UAP-HF-08143, Rev.0

**MHI's Response to NRC's Request for Additional Information on  
"Design Data for TRACE Input Deck Preparation by ERI"**

August 2008  
(Non Proprietary)

Figure 1-1 Reactor Vessel Side View (1/2)

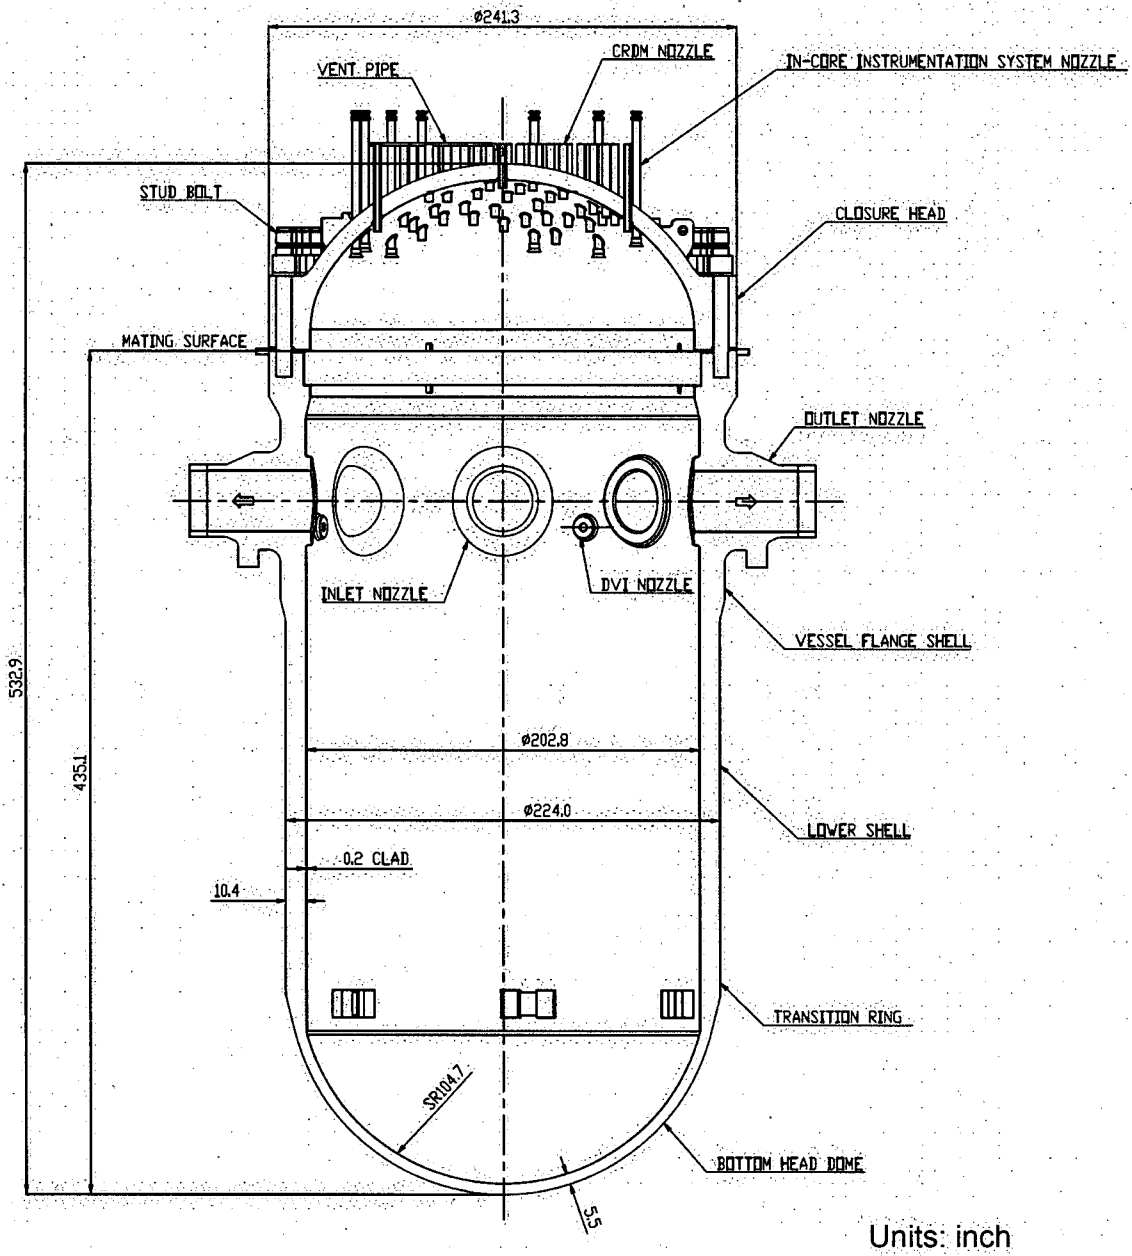
Detailed engineering drawings including various dimensions (e.g., length, thickness, elevation, etc.) of the reactor pressure vessel and its internals, pressurizer and steam generators. These drawings should also provide elevations for different penetrations in the above components.

Section 5.3 of the US-APWR Design Control Document (DCD) provides details regarding the US-APWR reactor vessel (RV) design. Figures 1-1, 1-2, and 1-3 (reproduced from DCD Chapter 5) provide dimensions of the reactor vessel and its internal components. Table 1-1 provides elevations that correspond to the numbered RV subregions depicted in Figure 1-1(1/2). Table 1-2 summarizes the reactor vessel design data used in the DCD Chapter 15 safety analysis. Table 1-3 shows the number of upper core internals assembly components used in the safety analysis corresponding to items shown in Figure 1-3. Flow areas and volumes of the reactor vessel subregions are provided in Table 4-1 as part of the response for Request-4.

Figure 12-1 High Head Safety Injection Flow Characteristic Curve (Minimum Safeguards)  
(Source: DCD Figure 6.3-15)

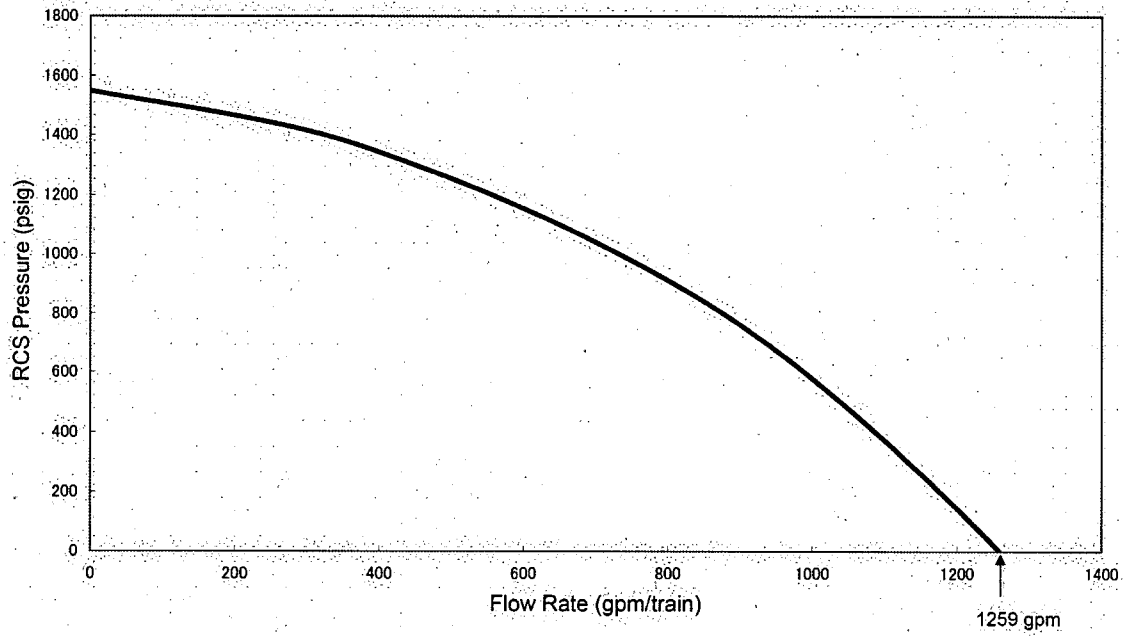
Pump characteristics (head versus flow) for the High Head Injection System, including rated head and the rated torque.

High head safety injection flow characteristics for minimum and maximum safeguards are provided for the system in Table 12-1 and Table 12-2. The data of Table 12-1 is also shown in Figure 12-1, which is taken directly from Figure 6.3-15 in Chapter 6 of the DCD for the US-APWR. And the data of Table 12-2 is also shown in Figure 12-2, which is taken directly from Figure 6.3-16 in Chapter 6 of the DCD for the US-APWR.
